# UNITED STATES PATENT AND TRADEMARK OFFICE

10/807,420

## Office Action Summary

## **DETAILED ACTION**

FIG. 9

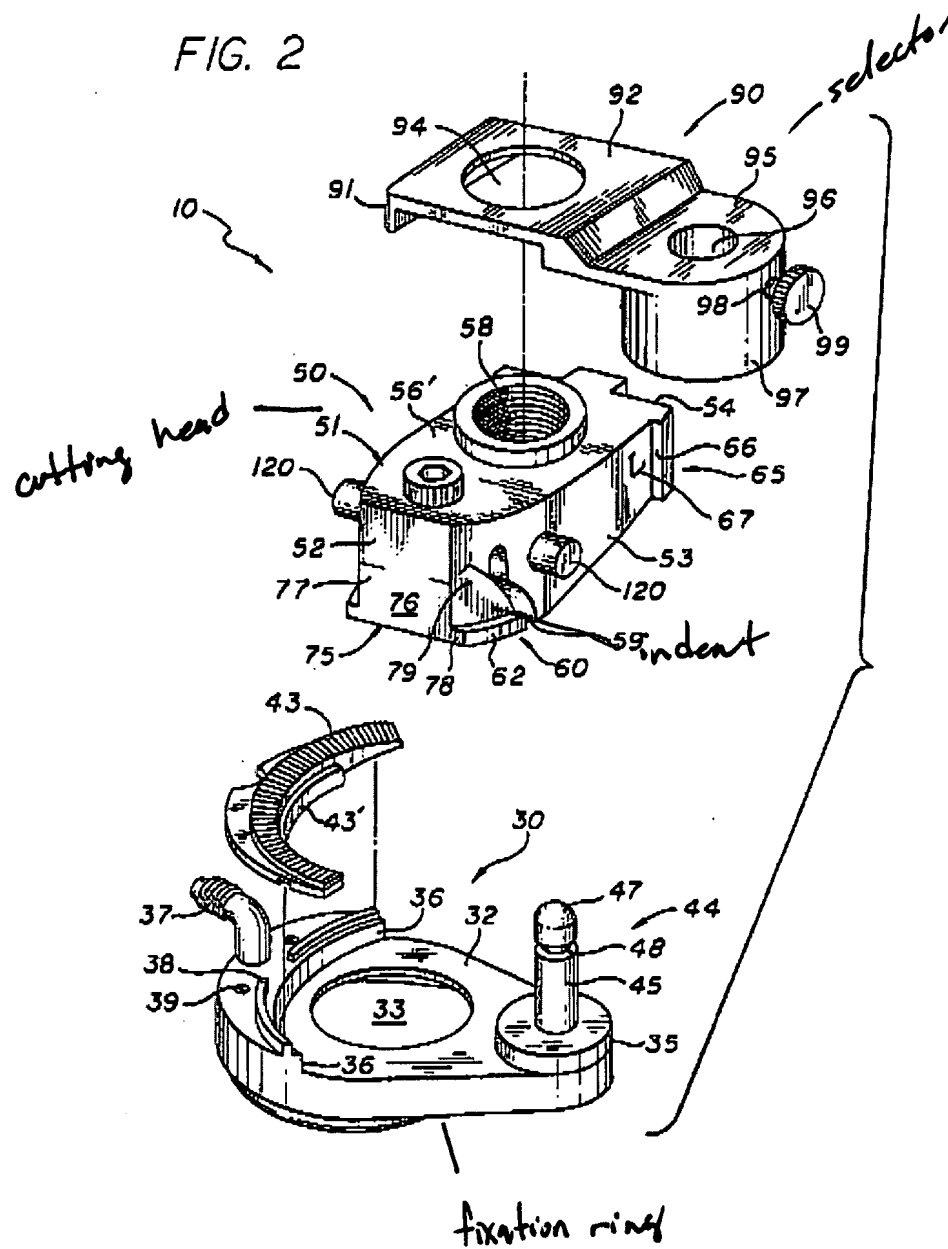
5. Hellenkamp teaches a microkerotome for use in ophthalmic surgery comprising: a bar-link drive; a cutting head; a fixation ring; wherein the bar-link drive moves the cutting-head at least partially across the fixation ring; a controller; wherein the drive includes a left/right selector; a cutting-head locator; wherein the cutting-head includes indents on opposite sides of the cutting-head; wherein the fixation ring includes structure extending beyond a bottom-most part of an annular ring and raised about the bottom-most part of the annular ring; a motor 100; and a translation stop 65.
